REQUEST FOR SITE APPROVAL

FROM: Name Hunter Co. of WV Phone 1-304-262-2770Address 1800 West King St. Martins WV 25401RE: Property Location Ashton Woods Sub.

Lot 144

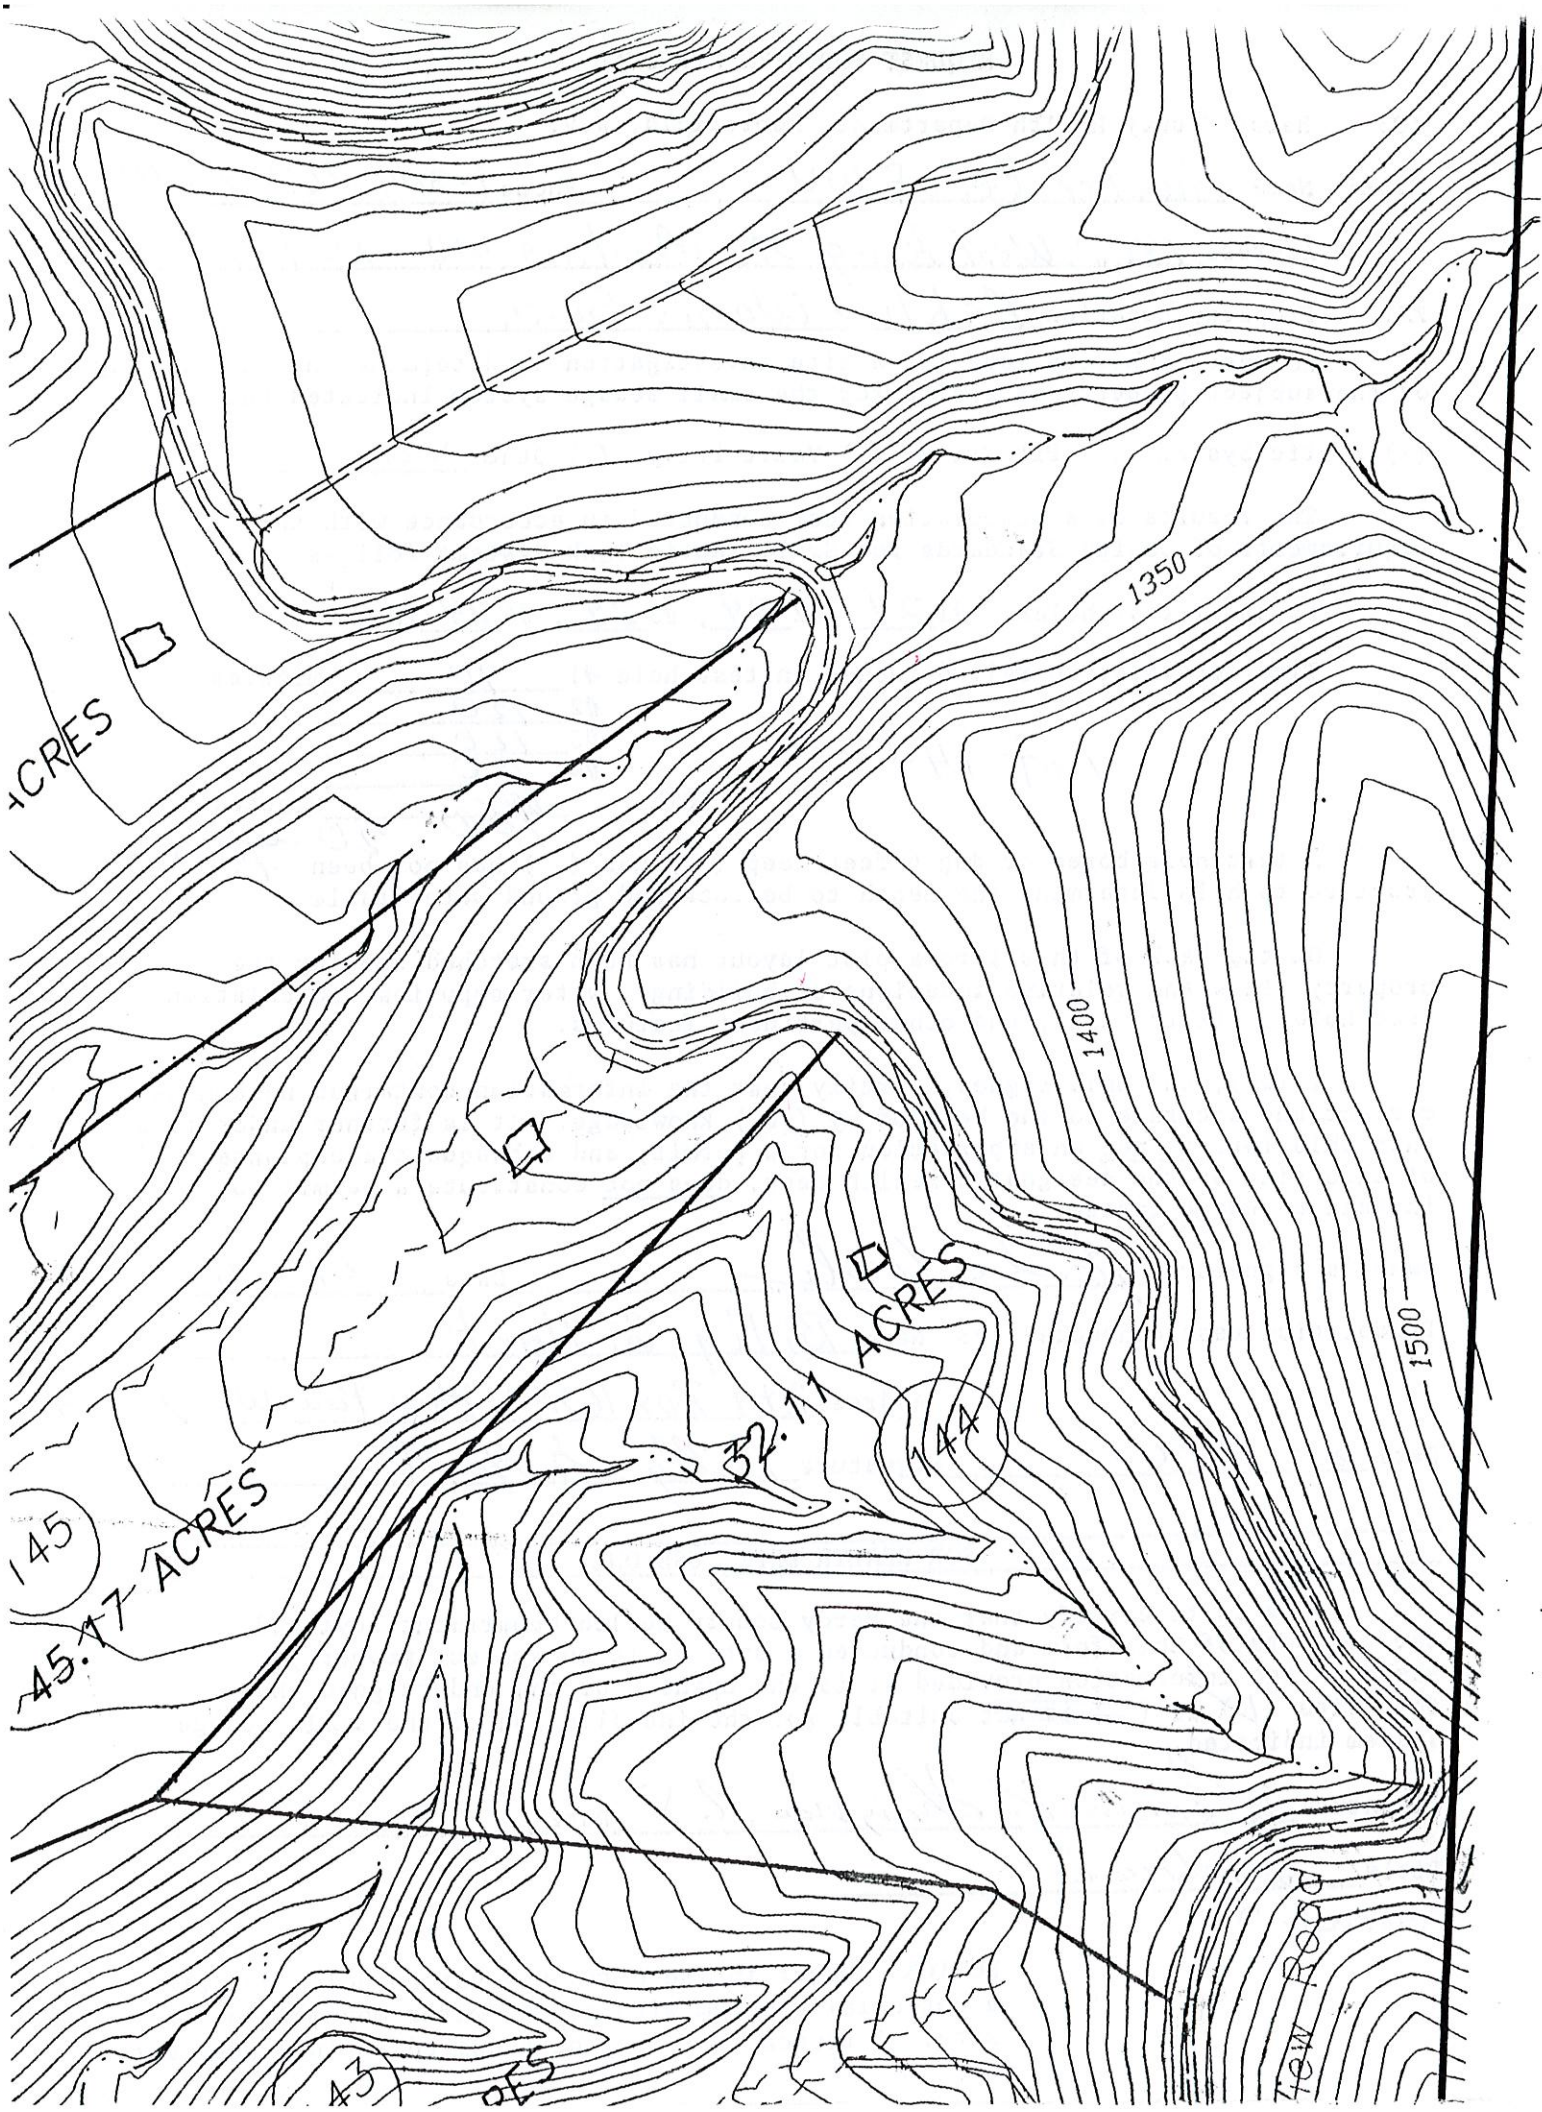
This is to certify that the Hardy County Health Department reviewed the contents of this form and conducted a site visit on subject property. Based on the information provided it is the opinion of the undersigned that this site (☒) is (~~is~~) is not suitable for the installation of the small sewage system indicated.

Water 2 1/2'

NOTICE: Water in the 6-ft observation hole indicates a potential problem with ground water movement on this site. A french drain may be required to intercept water.
